72+COLLINS DEVELOPMENT

CITY OF MIAMI BEACH
DESIGN REVIEW BOARD

MARCH 2, 2021

72 COLLINS HOTEL & CONDOMINIUM
MIAMI BEACH, FL

GROUND LEVEL - PHASE 1

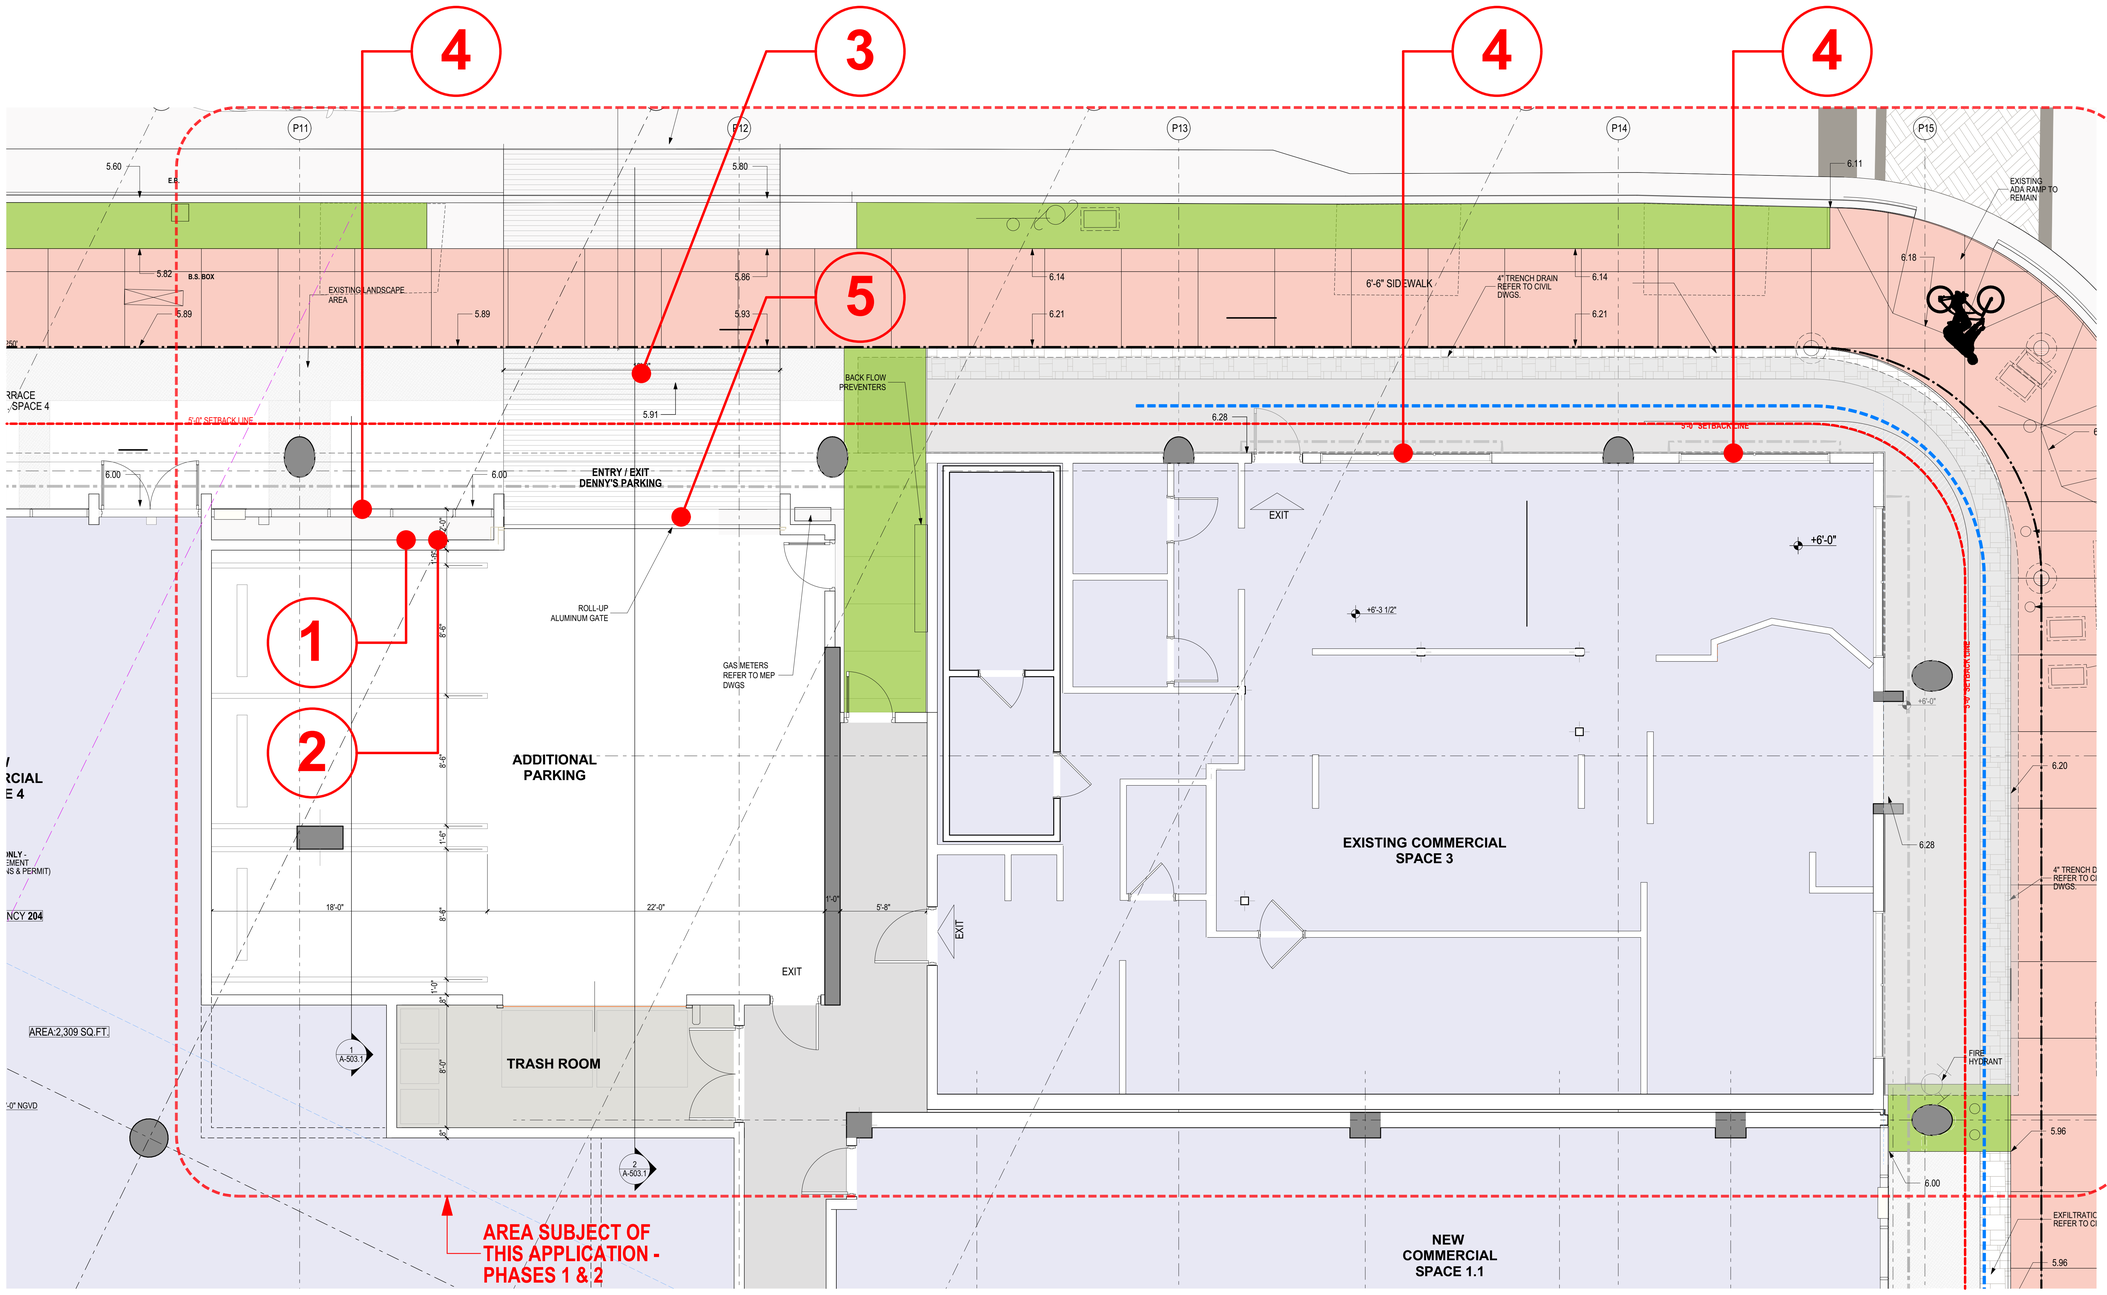
PROPOSED MODIFICATIONS ON PHASE 1

1. NEW CURB CUT
2. NEW ROLL-UP GATE - ENTRY TO ADDITIONAL PARKING
3. NEW ADDITIONAL PARKING
4. DISPLAY WINDOW
5. ADDITIONAL TRASH ROOM
6. COLUMN RELOCATION

8.	CLOSING OF CURB CUT
9.	NEW LANDSCAPE AND HARDSCAPE TO MATCH ADJACENT AREAS
10.	REPLACE GATE WITH STOREFRONT
11.	INSTALL NEW RETAIL DOOR
12.	COLUMN REMAIN IN THIS LOCATION
13.	COMPLETION OF RETAIL SPACE

PARTIAL GROUND LEVEL FLOOR PLAN | 1

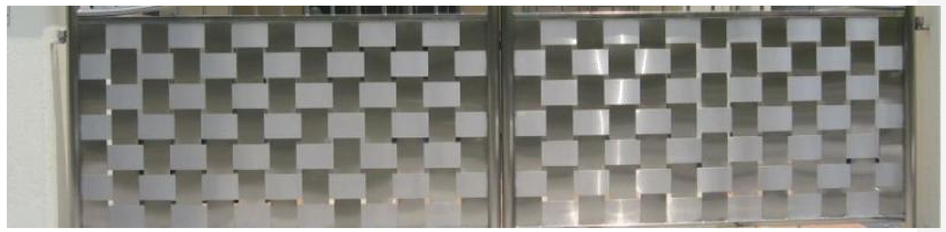
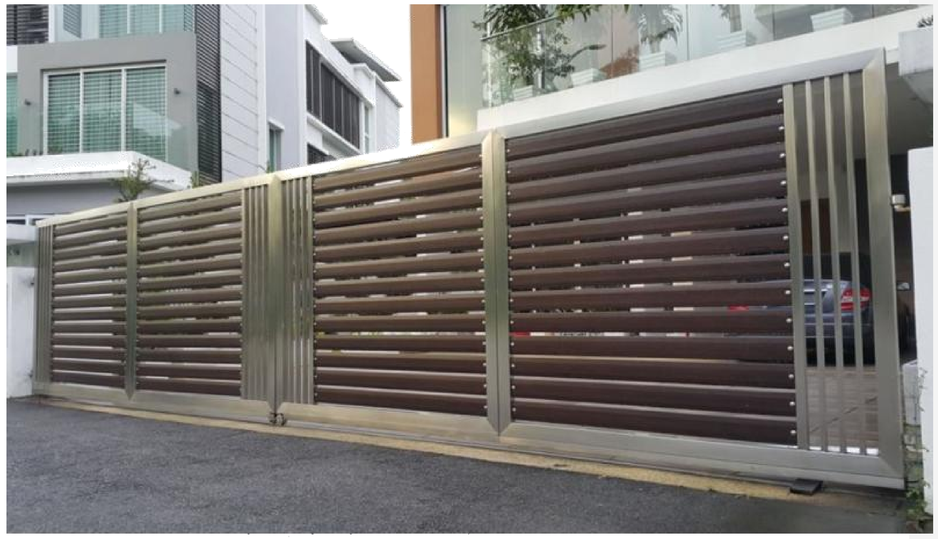
ALL OF THE VARIANCES ARE ONLY REQUIRED FOR THE **TEMPORARY PHASE 1** IMPROVEMENTS TO ACCOMODATE THE DENNY'S LEASE.

1. SEC. 142-745 (e)(2)(b). EXCEPT WHERE REQUIRED FOR DRIVEWAYS AND UTILITY INFRASTRUCTURE, THE GROUND FLOOR SHALL CONTAIN HABITABLE SPACE WITH A MINIMUM DEPTH OF 50 FEET FROM BUILDING FACADE. **2 FT PROVIDED.**

2. SEC. 142-745 (e)(2)(e). GROUND FLOOR AND SURFACE PARKING SHALL SETBACK A MINIMUM OF 50 FEET FROM THE BUILDING FACADE AND BE CONCEALED FROM VIEW FROM THE CLEAR PEDESTRIAN PATH. **2 FEET PROVIDED.**

3. SEC. 142-745 (e)(3). DRIVEWAYS AND VEHICLE ACCESS TO OFF-STREET PARKING AND LOADING SHALL BE PROHIBITED ON CLASS A FRONTAGE, UNLESS IT IS THE ONLY MEANS OF EGRESS TO THE SITE. **ONE DRIVEWAY PROVIDED ON 72 STREET, WHIS IS A CLASS "A" FRONTAGE.**

4. SEC. 142-745 (a)(8)(b). FRONTAGE FOR COMMERCIAL, HOTEL, AND ACCESS TO UPPER LEVEL FRONTAGE SHALL CONTAIN A MINIMUM OF 70 PERCENT CLEAR GLASS WINDOWS WITH VIEWS INTO HABITABLE SPACE. **21.56 % PROVIDED.**

5. SEC. 142-745 (a)(10)(a). PARKING FACILITIES SHALL BE ENTIRELY SCREENED FROM VIEW FROM PUBLIC RIGHTS-OF-WAY AND CLEAR PEDESTRIAN PATHS.

ELEVATION NORTH CORNER FACADE - PHASE 1

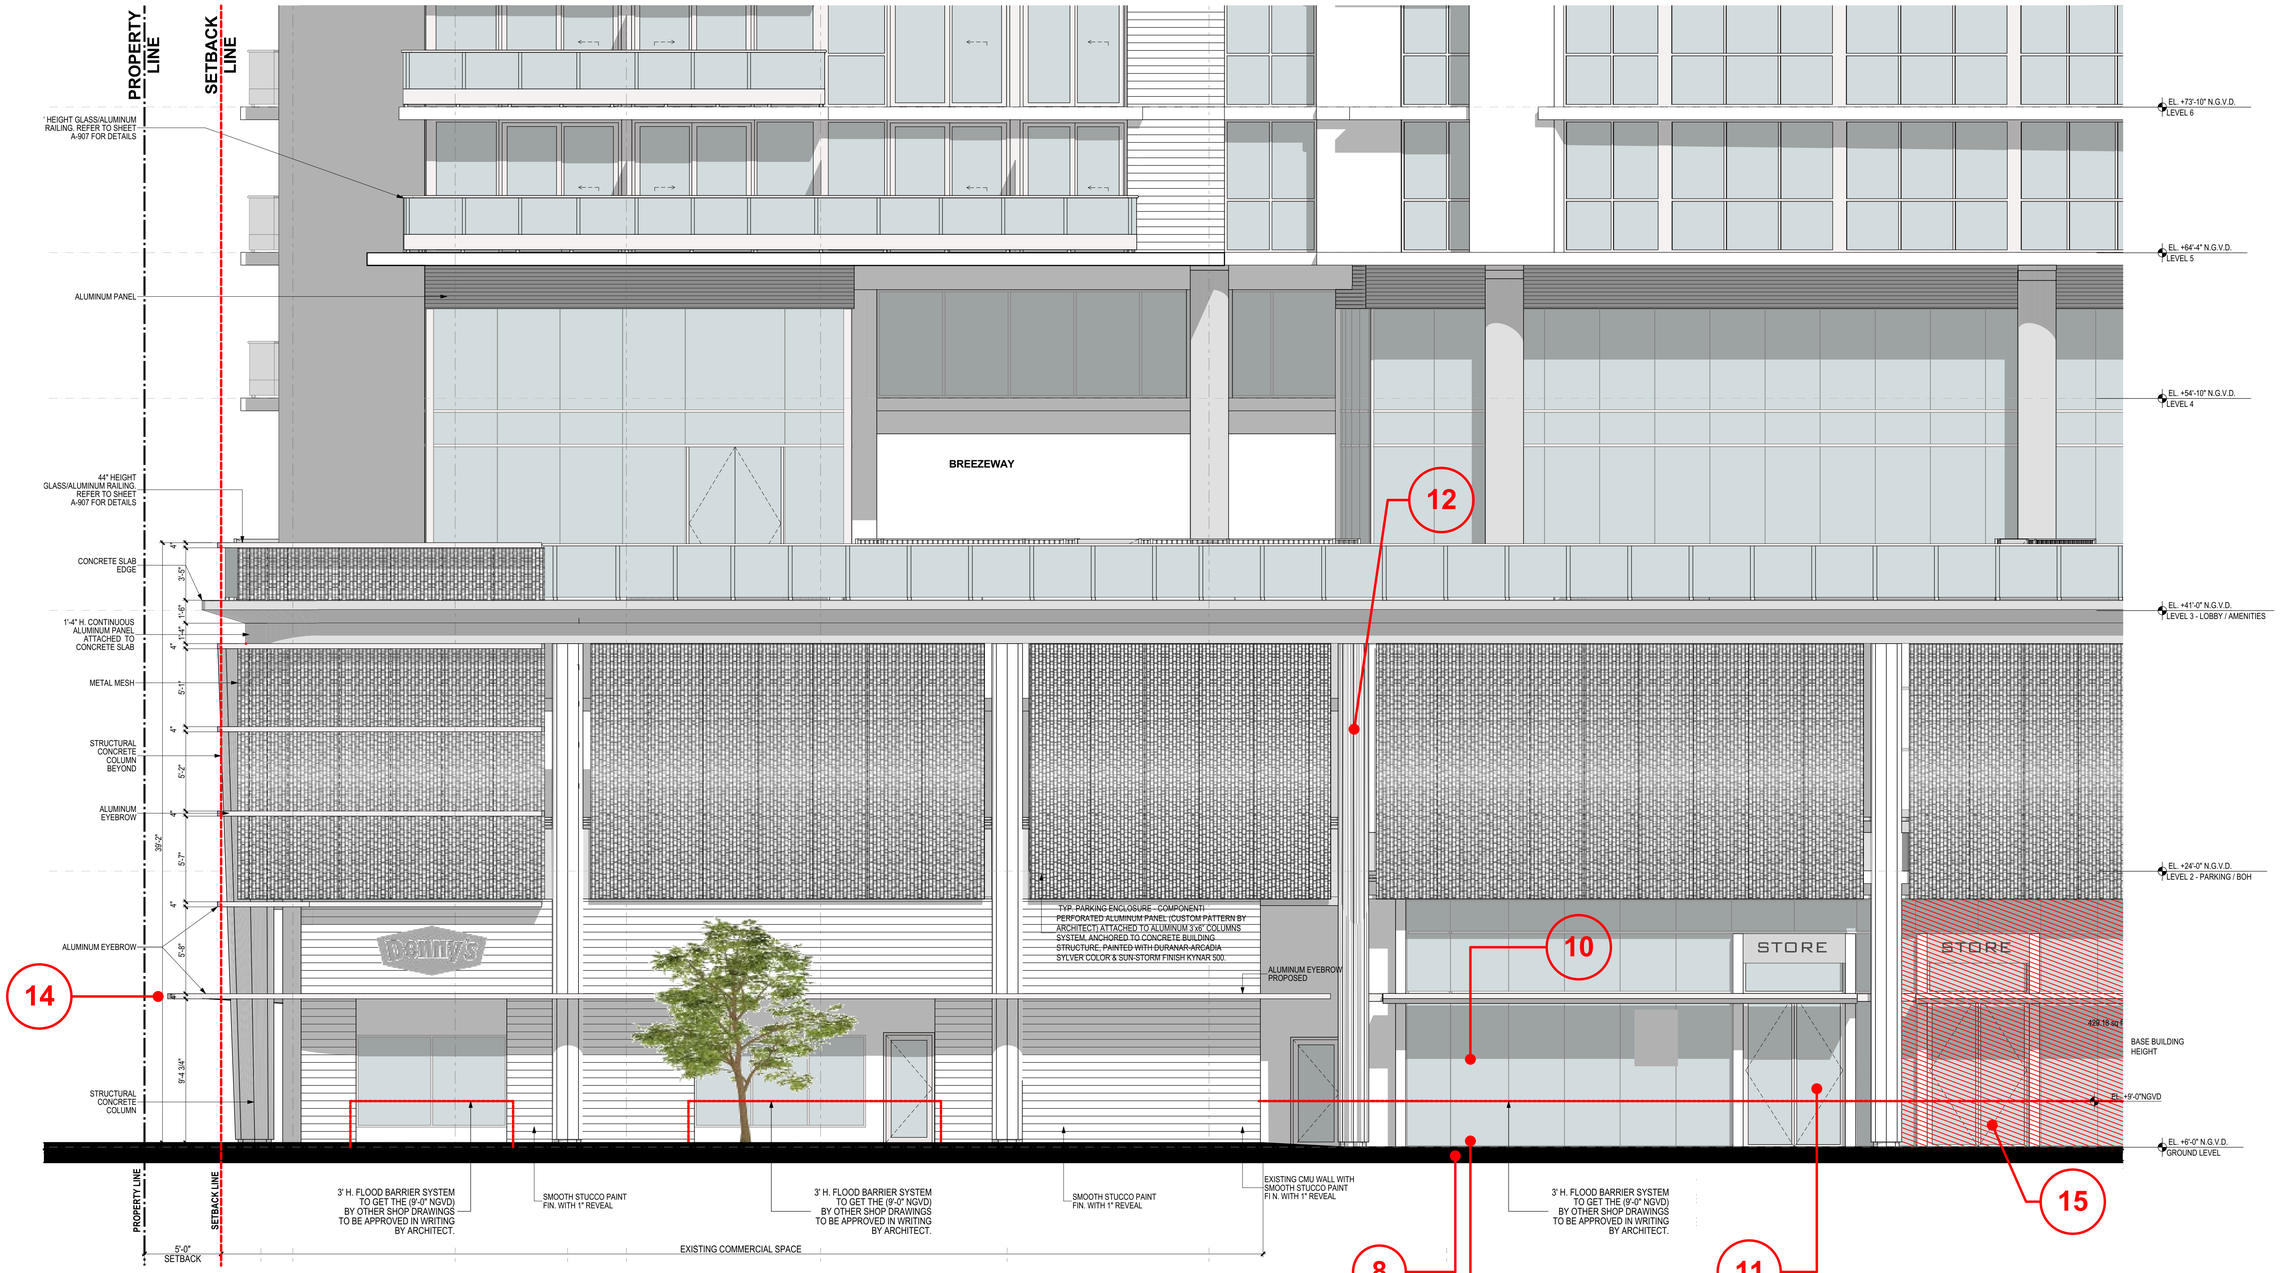
PROPOSED MODIFICATIONS ON PHASE 1

1.	NEW CURB CUT
2.	NEW ROLL-UP GATE - ENTRY TO ADDITIONAL PARKING
3.	Not used
4.	DISPLAY WINDOW
5.	Not used
6.	COLUMN RELOCATION
7.	ALUMINUM AWNING/EYEBROW EXTENDED TO MATCH FOOTPRINT OF EXISTING CONSTRUCTED AWNING

ELEVATION NORTH CORNER FACADE - PHASE 2

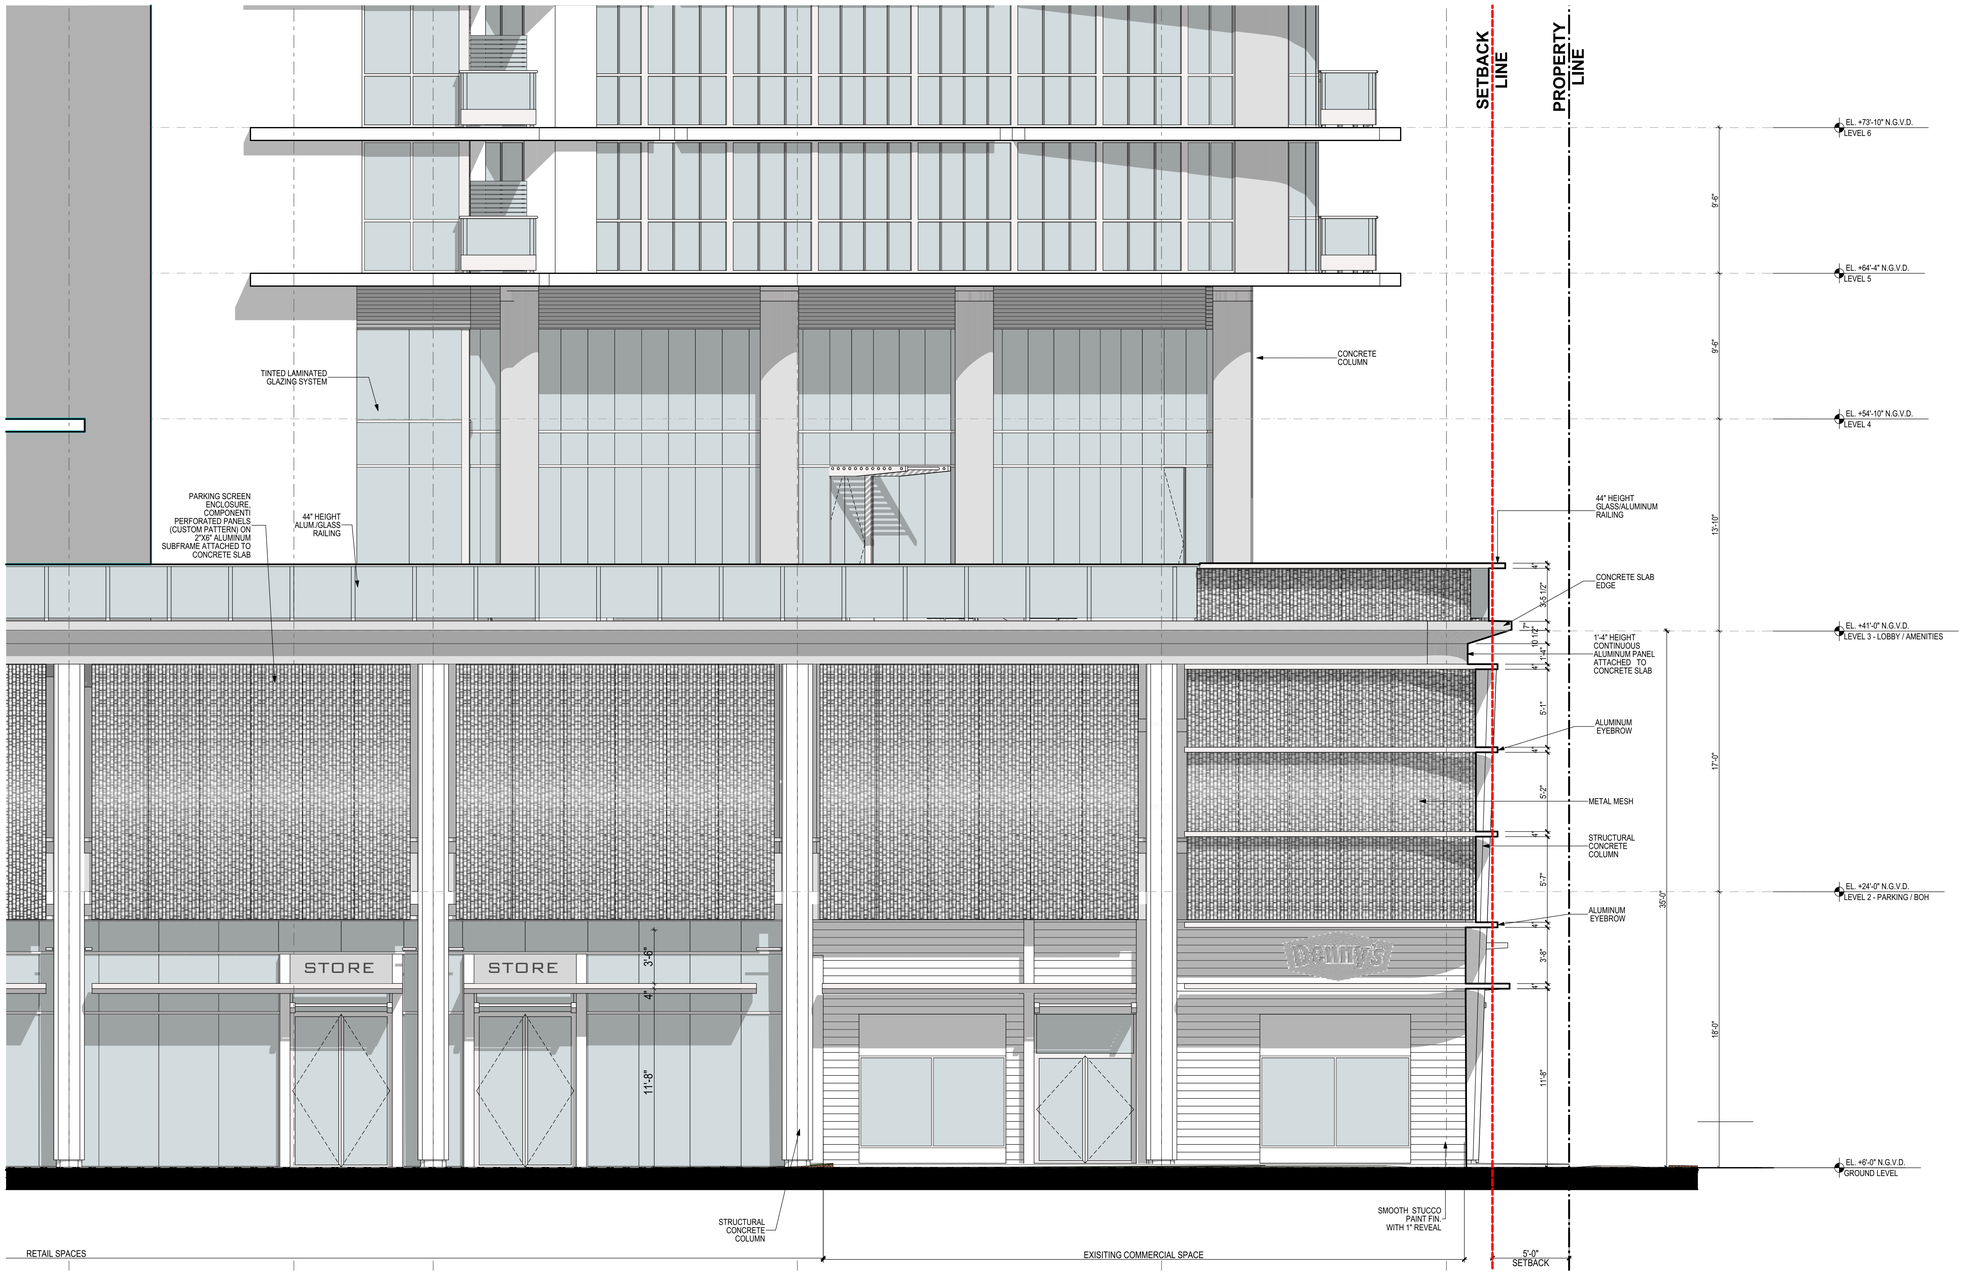
8.	CLOSING OF CURB CUT
9.	NEW LANDSCAPE AND HARDSCAPE TO MATCH ADJACENT AREAS
10.	REPLACE GATE WITH STOREFRONT
11.	INSTALL NEW RETAIL DOOR
12.	COLUMN REMAIN IN THIS LOCATION
13.	COMPLETION OF RETAIL SPACE
14.	ALUMINUM AWNING/EYEBROW DIMENSIONS REMAIN
15.	RELOCATION RETAIL DOOR
